TOWN OF ADDISON CHANGE ORDER FORM

Change Order Number: 2

Project Name: Addison Airport US Customs and Border Protection Facility

Date: 05/20/2020

Penal-Ware® 1415: 15" Lav-Toilet Comby with Lavatory Multi-Sided Bowl

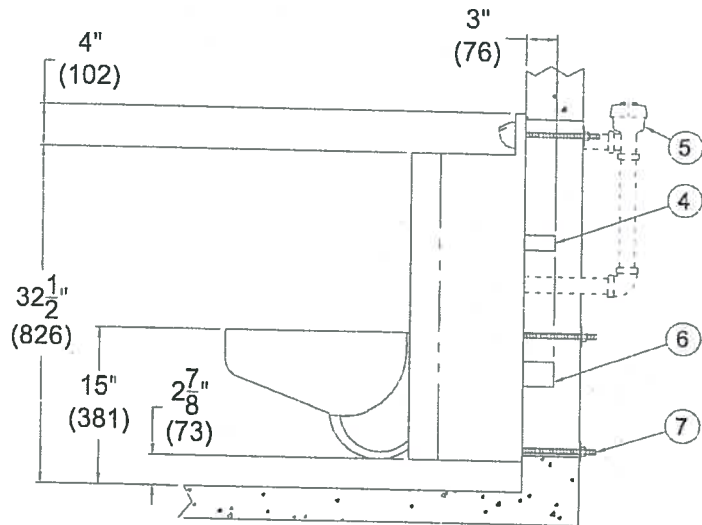
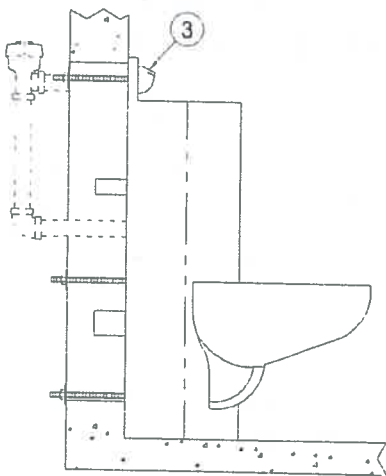
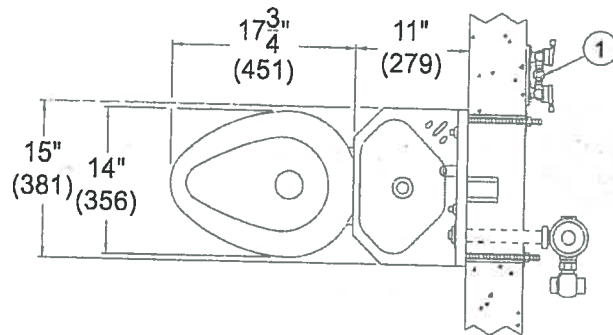
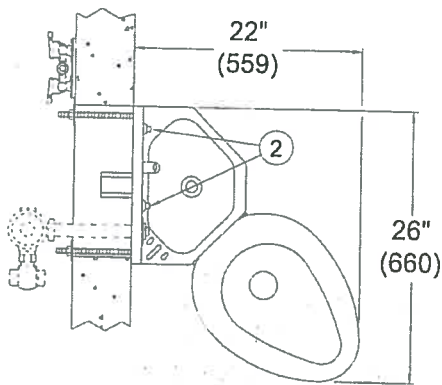
- As requested by Customs and Border Protection, hold room toilets and lavatory were revised from separate toilets and lavatory to combination toilet/lavatory fixtures.

Plumbing bid per RFI 89 and specs. Including the following fixtures;

- Install and provide new WC/Lavatory combo unit
- Change fixture type from fixture schedule to RFI 89
- 6-8 week lead time from the factory (non-stock item)
- Pricing based on normal work hours M-F, no expedited schedule
- MEP ceiling coordination meeting will be required prior to overhead piping
- Fixtures to be per schedule or equal.

Provide and install Acorn Penal-Ware® 15" wide Lav-Toilet Comby (specify model number and options). Fixture shall be fabricated of type 304 stainless steel. Construction shall be seamless welded and exposed surfaces shall have a satin finish. Countertop shall have raised soap ribs. Provide Air-control pneumatically operated pushbutton valve. Valve and bubbler conform with lead free requirements for NSF61, Section 9 and CHSC 116875. Toilet shall be concealed blowout jet type with an elongated bowl, a self-draining flushing rim, and an integral contoured seat. Toilet shall meet ASME A112.19.3 and CSA B45.4 requirements and will flush with a minimum of 25 PSI flow pressure when used in conjunction with a minimum of 1.28 gpf. Toilet trap shall have a minimum 3-1/2" seal that shall pass a 2-1/8" diameter ball and be fully enclosed. Cabinet interior is sound-deadened with fire-resistant material. Fixture shall withstand loadings of 5,000 pounds without permanent damage. Fixture shall be furnished with necessary fasteners for proper installation.
